VARIANCE APPLICATION SUMMARY

File Number	V-25-8
Property Address	3590 CLOTTS RD GAHANNA, OH 43230
Parcel ID	025-003899
Zoning District	R-1 - Large Lot Residential
Project/Business Name	Morris Residence
Applicant	Matt Toddy matt@elevationstudio.us 330-697-8525
Description of Variance Request	Requesting a variance from the R-1 side yard setback requirement of 15' to match the existing structure side yard setback of 11'-2".

Reference: 3590 Clotts Road – Variance Application

Staff Review

**ARCHITECTURAL
SITE PLAN**

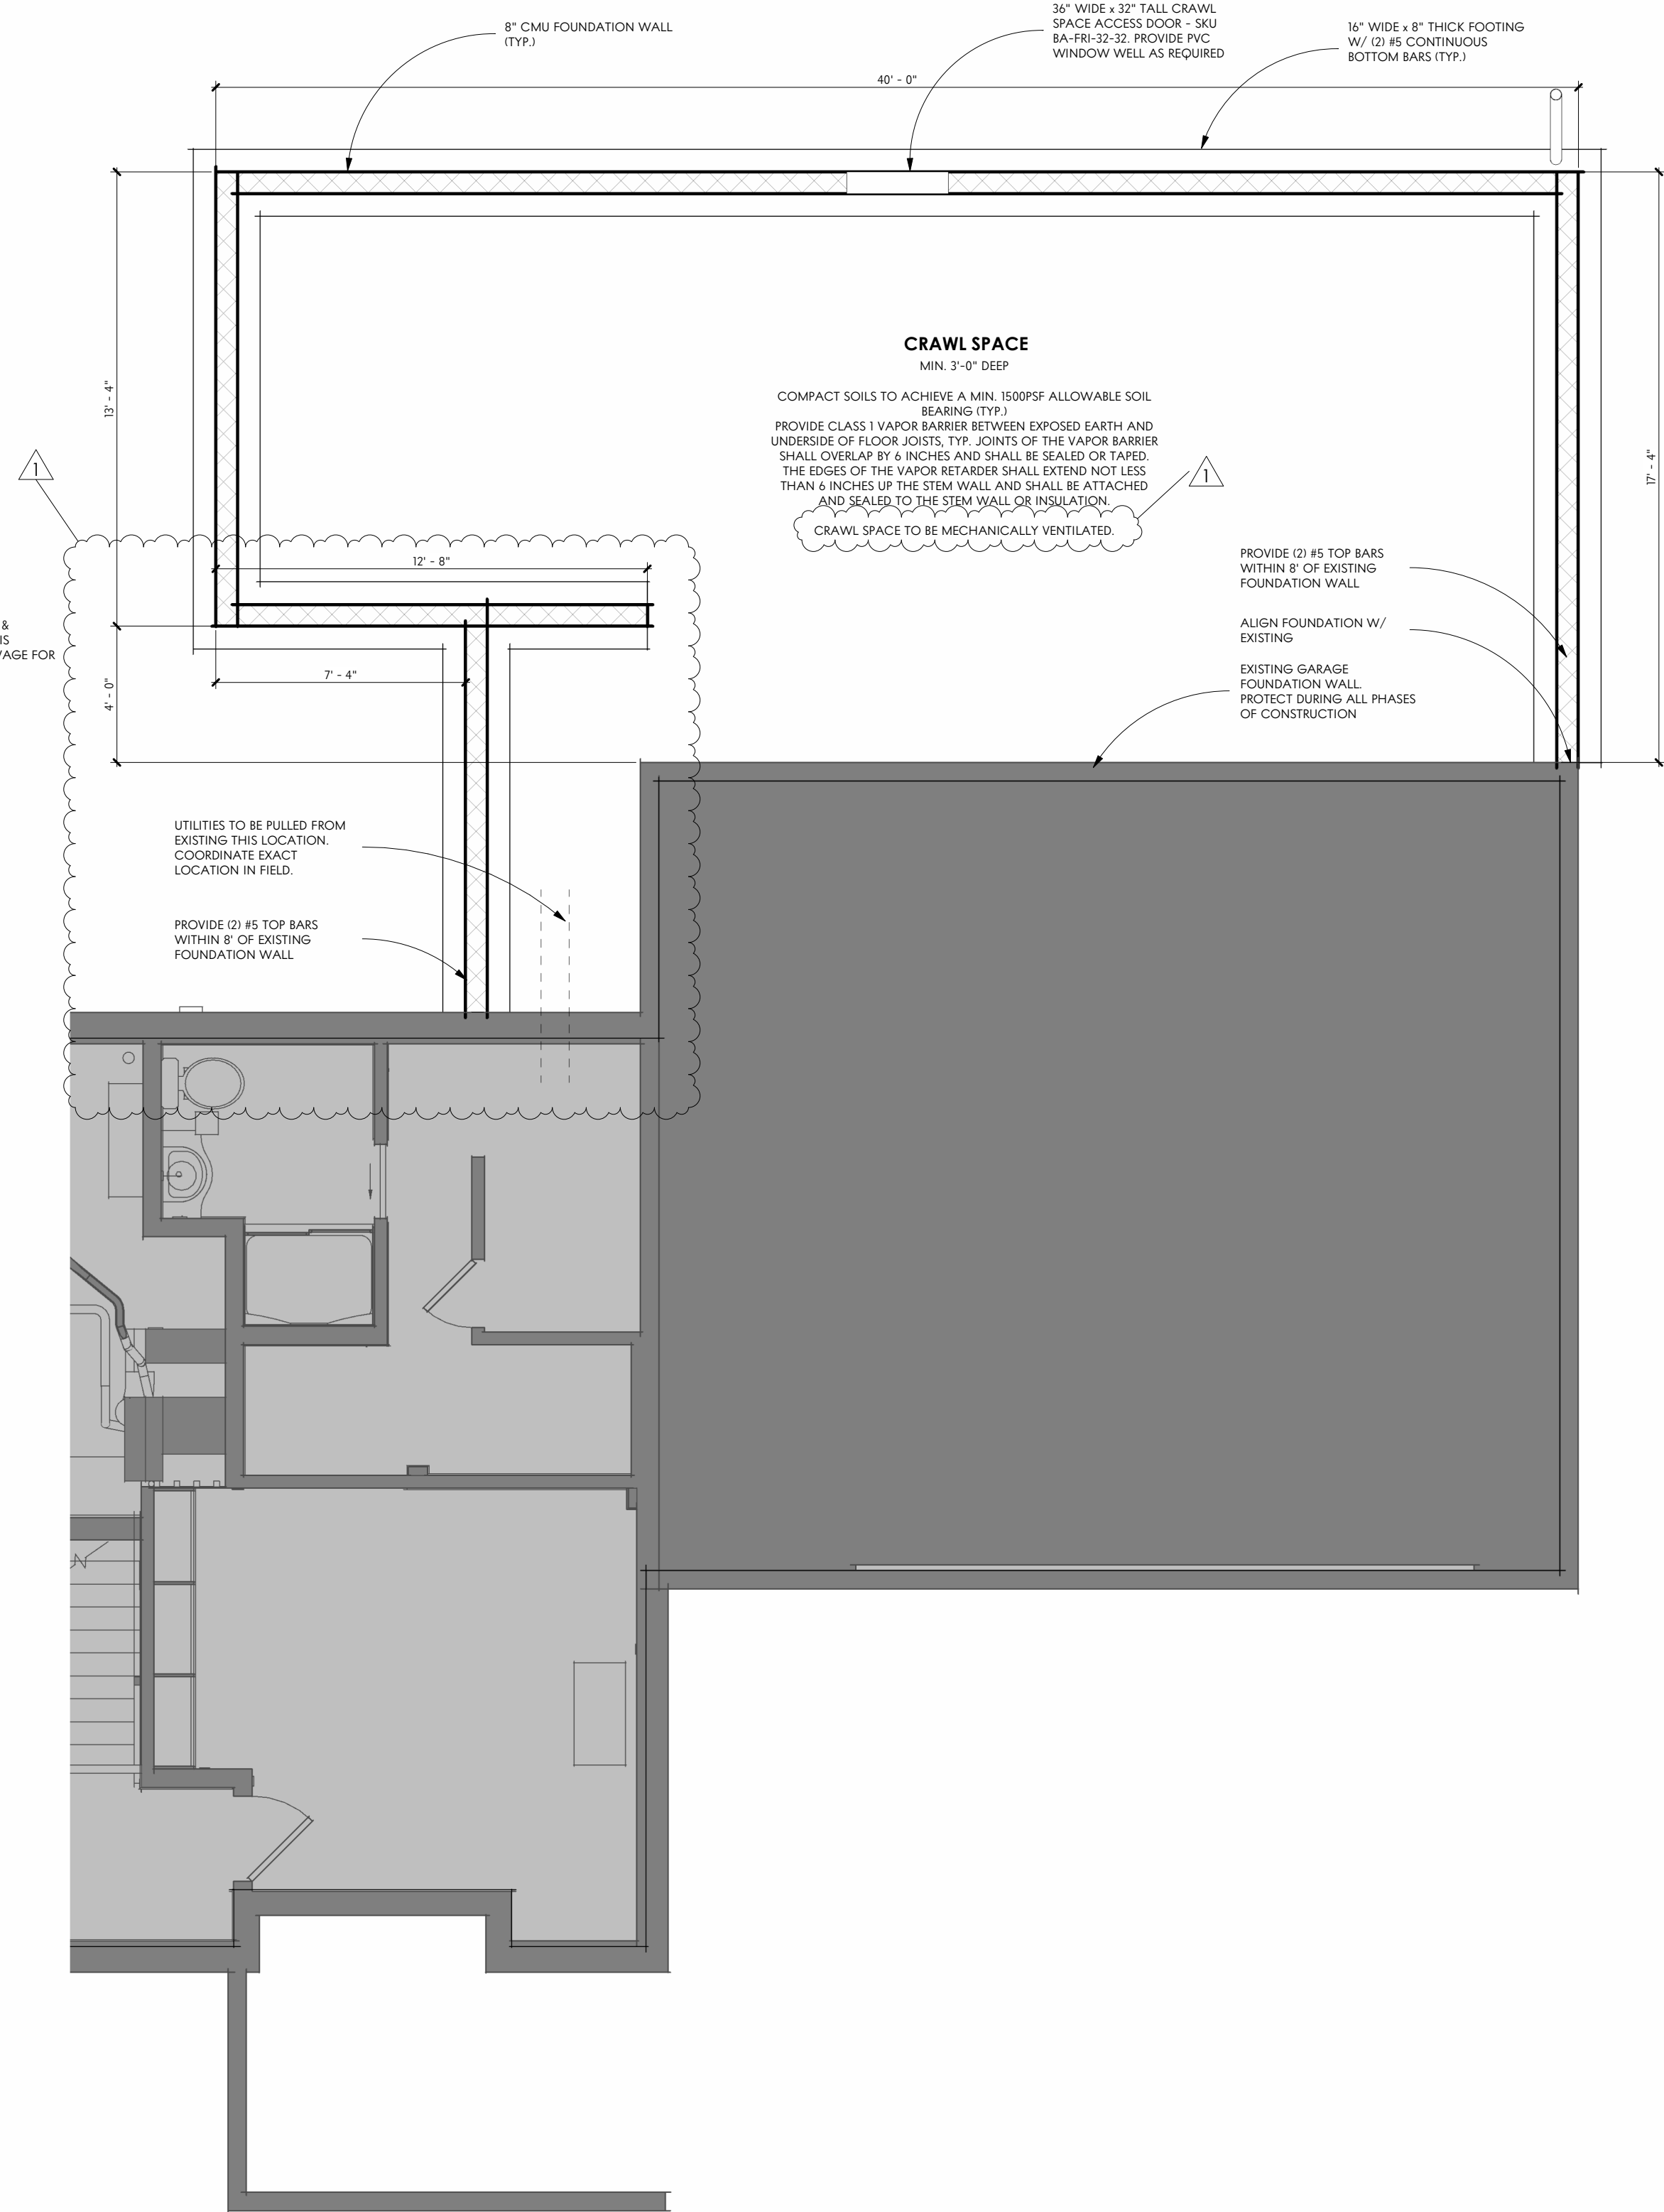
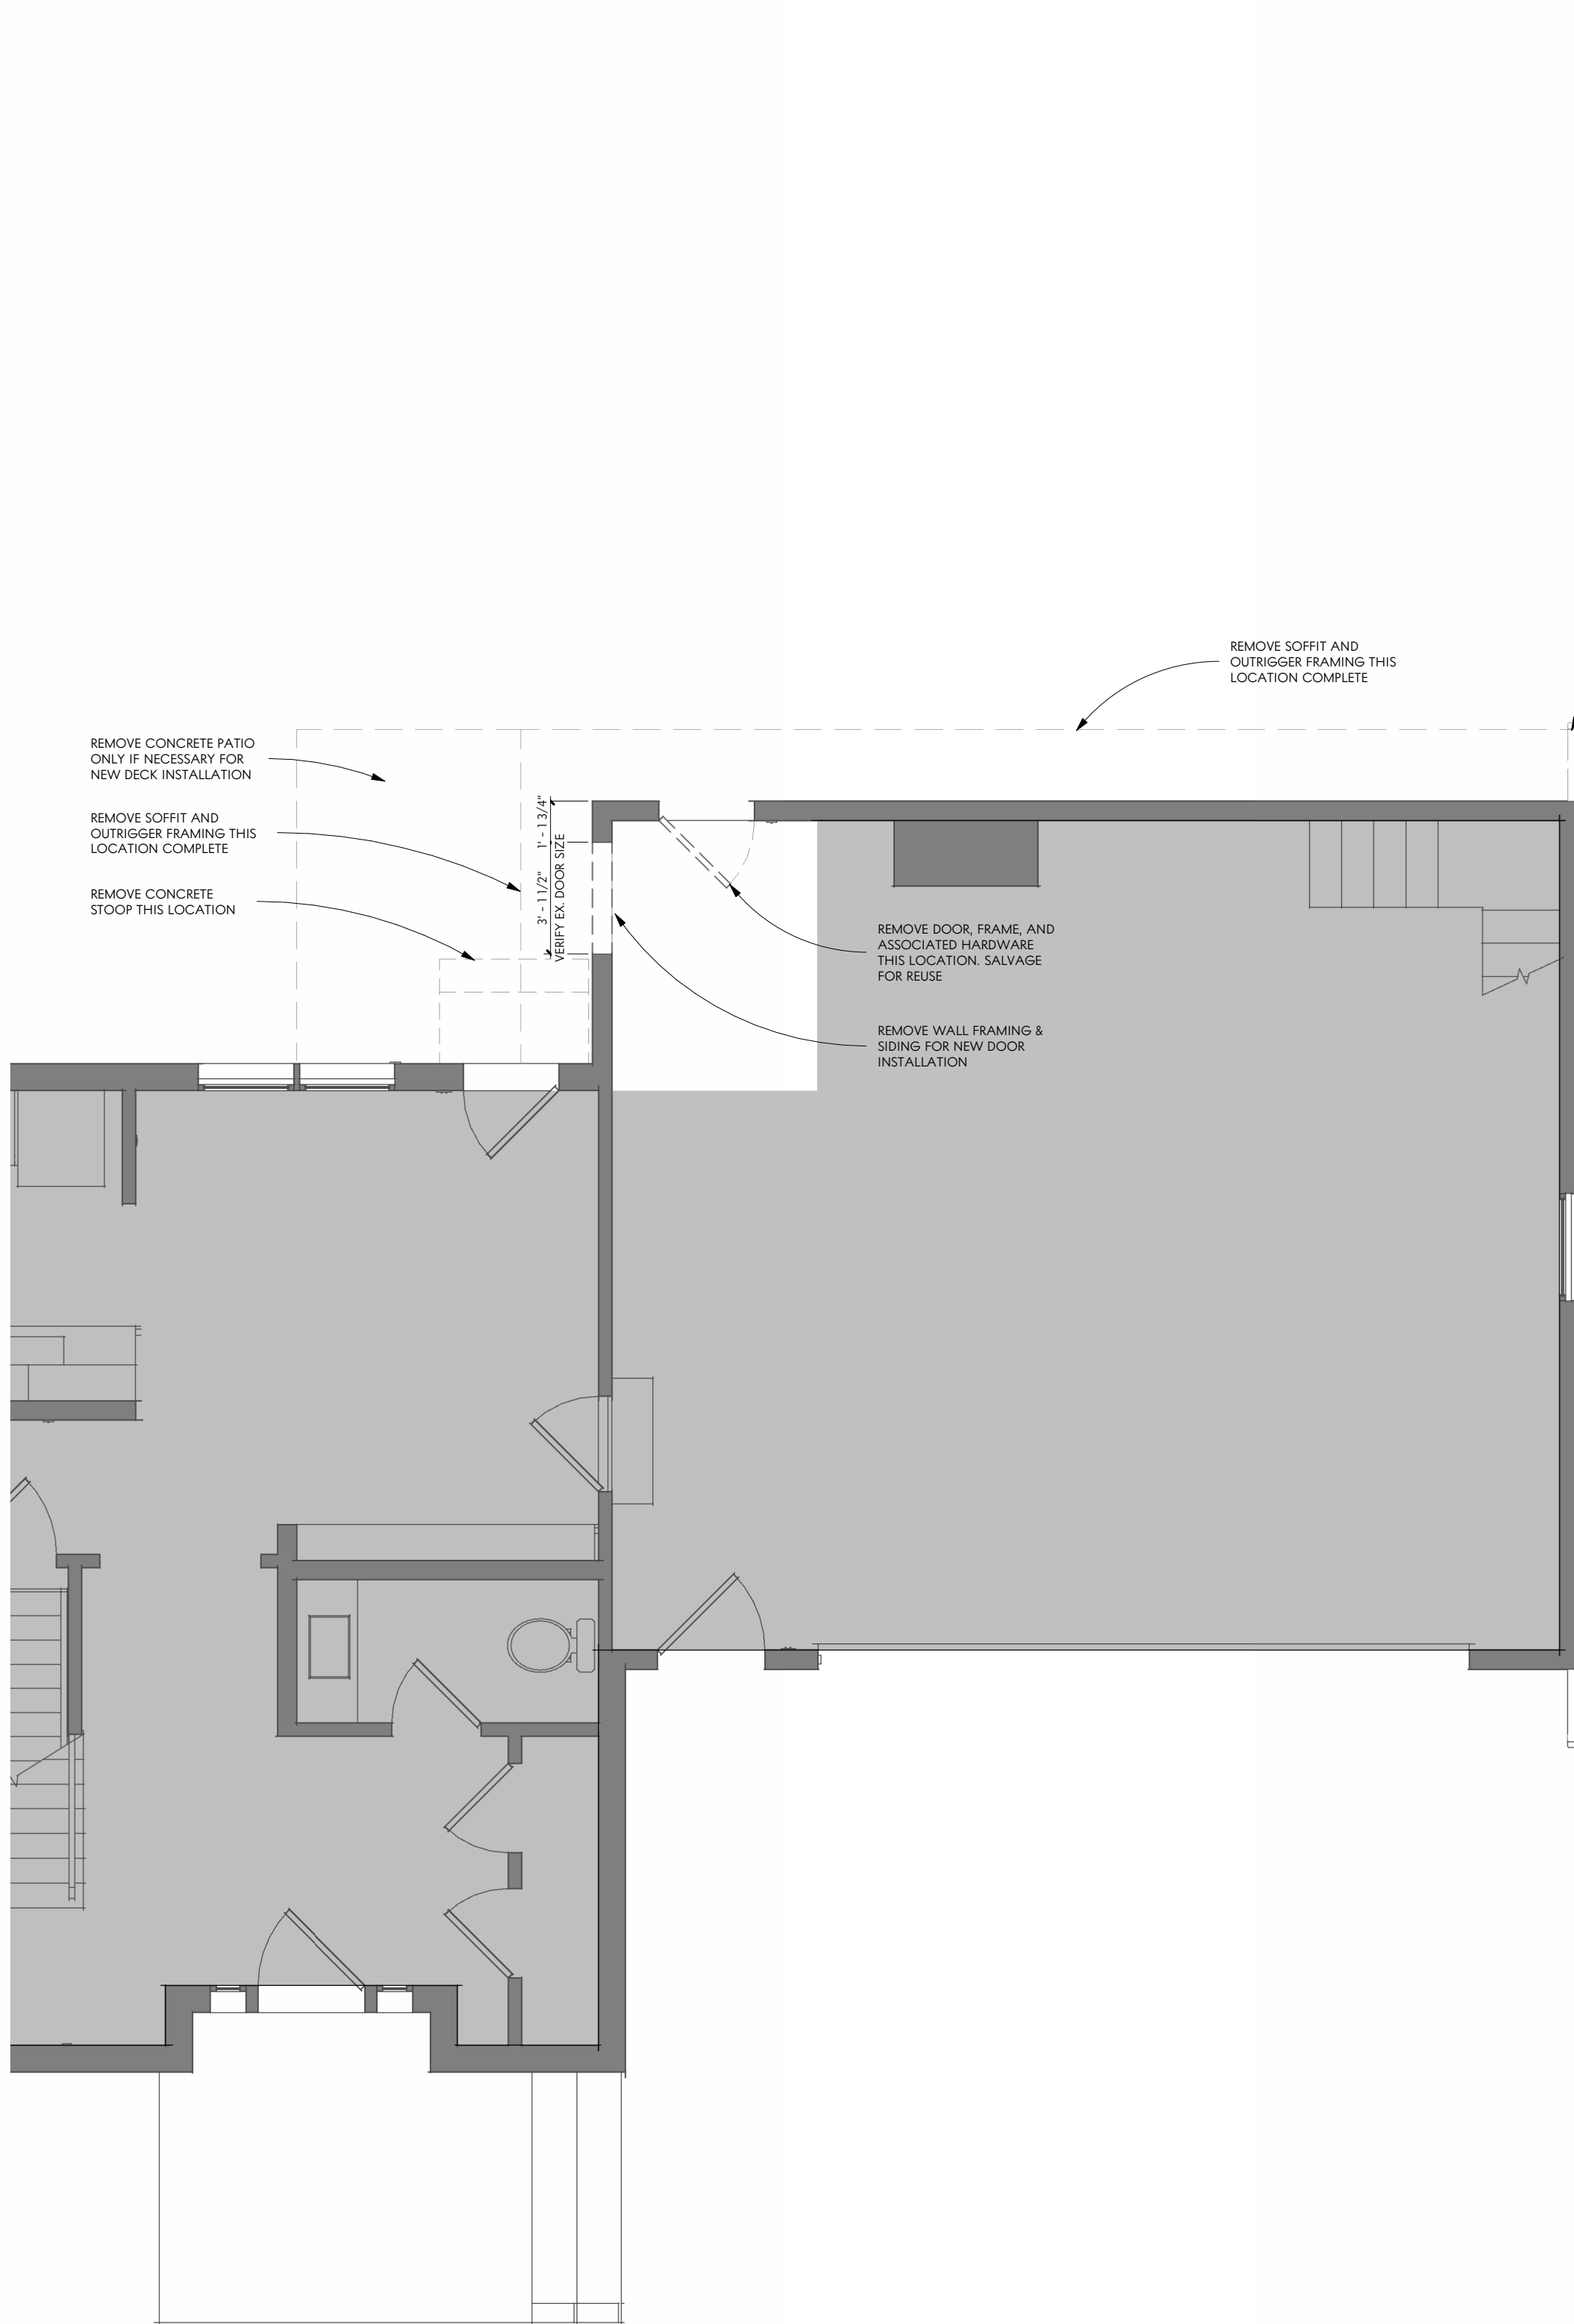
The applicant is requesting approval of a variance to allow an addition within a side yard setback. The zoning code requires a 15 ft side yard setback for all properties zoned R-1. The addition would be attached to the rear of the existing house and constructed in line with the south façade of the house at 11 ft 2 in from the side property line.

1. 1103.07(e) – Large Lot Residential
 - a. The principal structure must be at least 15 ft from the side property line.
 - b. The proposed addition is 11 ft 2 in from the side property line.

Staff recommends approval of the variance as submitted. The addition would be in-line with the existing house and other homes in the area. All other setbacks are met. There are also privacy fences separating this property from all adjacent properties that will partially screen the addition.
